**Re: Technical Submission Review – Metro Center Parcel A - Infrastructure Site Plan and Plat**  
Application Number: **DA-1489-25**  
Case Numbers: **2022 6034 00; 2022 3054 00**

## Technical Submission Review

2-WAY ELEVATED BIKE LANE  
ELEVATED BIKE LANE, NORTH SIDE  
OF CENTREPOINT

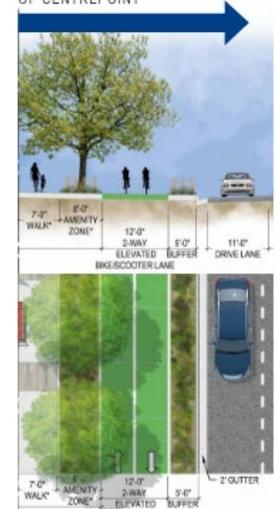
- 2A. A Master Plan Amendment is required based on the changes in the site plan submitted. The section cuts and bike network need to be updated. Public Works also requested the PIP be updated. All these changes can be included in the Master Plan amendment. Please get in touch with your case manager to begin the application.
- 2B. Centrepoint needs to have the elevated bike lane through Dawson Street. West of Dawson Street it can move to a share ROW. The application is currently missing a large section of the elevated Centrepoint bike lane. Please add include upon the third submission.
- 2C. This application does have a plat associated with the site plan. Planning does not see any issues with this Metro Center Plat ahead of recordation.
